August 28, 1992

Enclosed are the ABWR SSAR markups corresponding to the majority of the Piping Design Audit open items. The markups for the outstanding open items will be provided on the following schedule:

ABWR SSAR

AUDIT OPEN ITEMS

Figure 3.6-8 JET CHARACTERISTICS

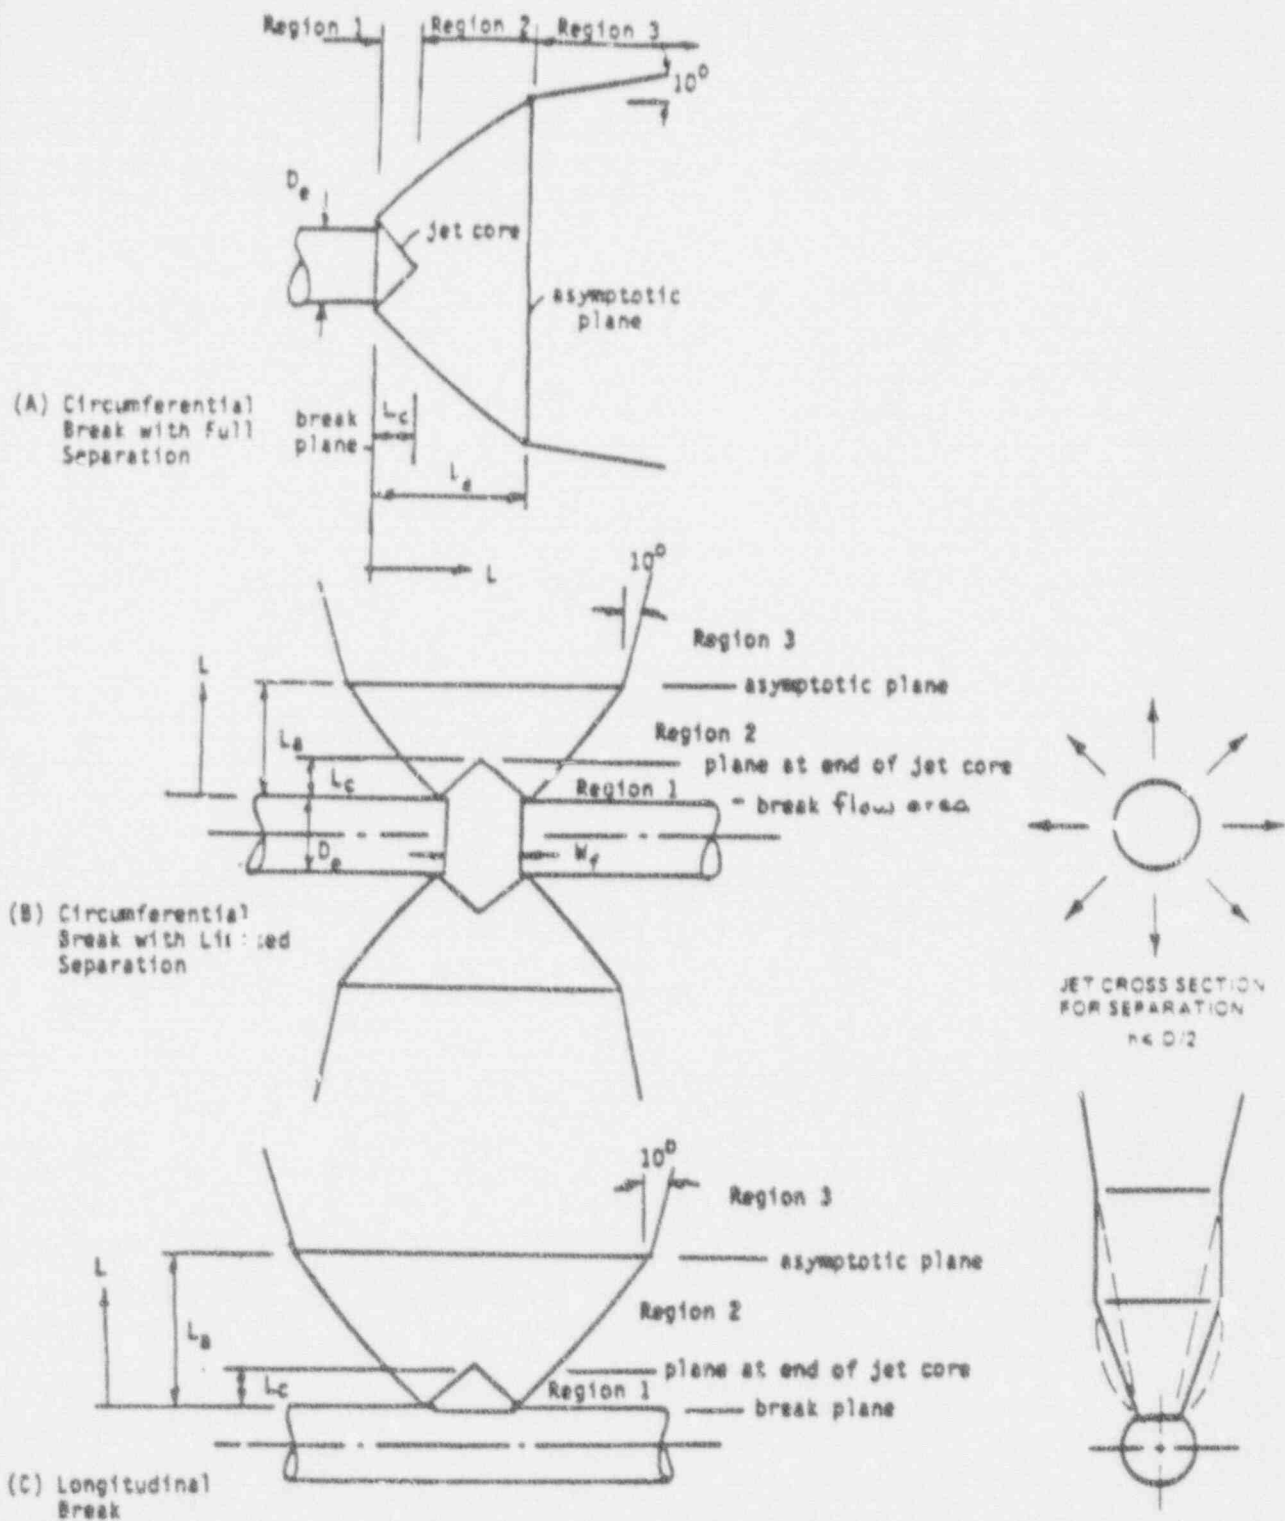
A steady state factor of 0.7 is used for ideal steam (see attached figure.)
